Access Compliance Report

Public Rights-of-Way

Intersection ID: 14469	Main Street: E_MOREHEAD_ST	Cross Street: KENILWORTH_AV	Location: W
ADA ID: 23FF5C337543	Ramp Type: PerpDiag	Initial Pass/Fail: Fail	Overall Compliance: No
Severity Score: 12.5			
Codes/Mitigation Info/Possible Solution		Field Measurements/Component Compliance

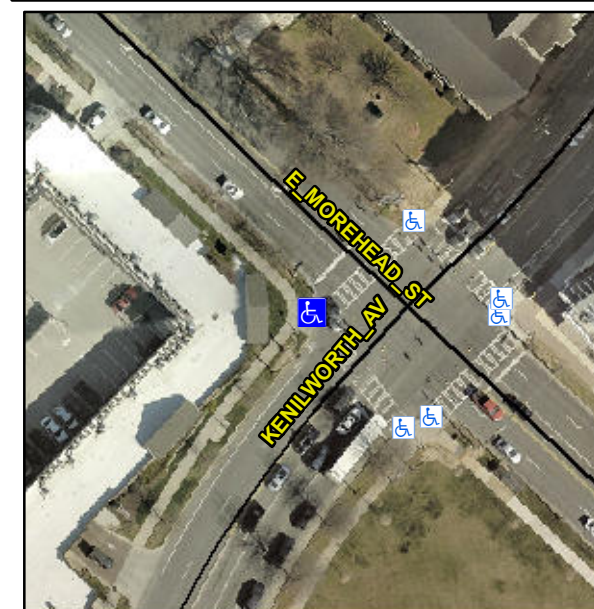
R304.2.2

Compliance	Description	Data	Compliance	Description	Data
N/A	Ramp Length (in)	96.0	No	Ramp Slope (%)	8.5
Yes	Ramp Width (in)	48.0	Yes	Ramp XSlope (%)	1.9
N/A	Flare Type LT	N/A	N/A	Flare Type RT	N/A
N/A	Flare Slope LT (%)	N/A	N/A	Flare Slope RT (%)	N/A
N/A	Flare Traversable LT?	N/A	N/A	Flare Traversable RT?	N/A
N/A	Landing Length (in)	N/A	N/A	DWS Provided?	N/A
N/A	Landing Width (in)	N/A	N/A	DWS Contrast?	N/A
N/A	Landing Slope (%)	N/A	N/A	DWS Length (in)	N/A
N/A	Landing X Slope (%)	N/A	N/A	DWS Full Width?	N/A
N/A	Landing Curb? (Y/N)	N/A	N/A	DWS Offset (in)	N/A
N/A	Shared Landing?	N/A			
N/A	Gutter Ponding?	N/A	N/A	Gutter Slope (%)	N/A
N/A	Gutter Lip Ht (in)	N/A	N/A	Gutter X Slope (%)	N/A
N/A	Painted X Walk1?	Yes	N/A	Painted X Walk2?	Yes
	X Walk 1 Direction	To SE		X Walk 2 Direction	To NE
N/A	X Walk 1 Width (in)	120.0	N/A	X Walk 2 Width (in)	111.0
	X Walk 1 Slope (%)	3.6		X Walk 2 Slope (%)	0.5
	X Walk 1 X Slope (%)	2.0		X Walk 2 X Slope (%)	1.6

Remove & Replace Curb Ramp With Two New Directional Ramps or Equivalent.
